# Rezoning Transportation Analysis

Petition Number: 2022-146

## Revision Log:

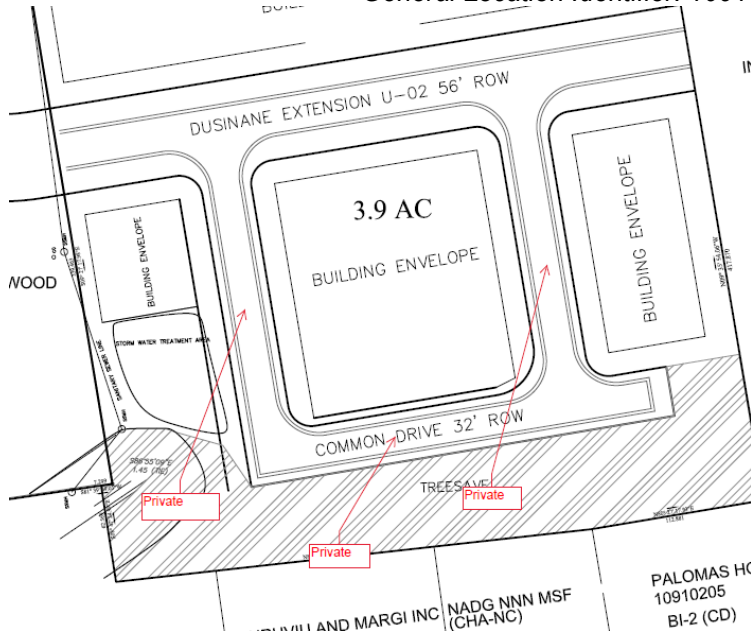
- 3. ~~Revise site plan and conditional note(s) to commit to construct an 8-foot planting strip, and 5-foot sidewalk on Dusinane Extension per Chapter 20. The site plan shall label and dimension both items from the back of curb and gutter or edge of pavement.~~

**Clarifying Comment 4-20-23:** Update conditional notes to commit to constructing Dusinane as a U-02 and constructing the 8 foot planting strip and 5 foot sidewalk.

- 4. ~~Revise site plan to remove public right of way designation for private streets as shown below. Label and provide CLDSM designation for proposed private streets.~~
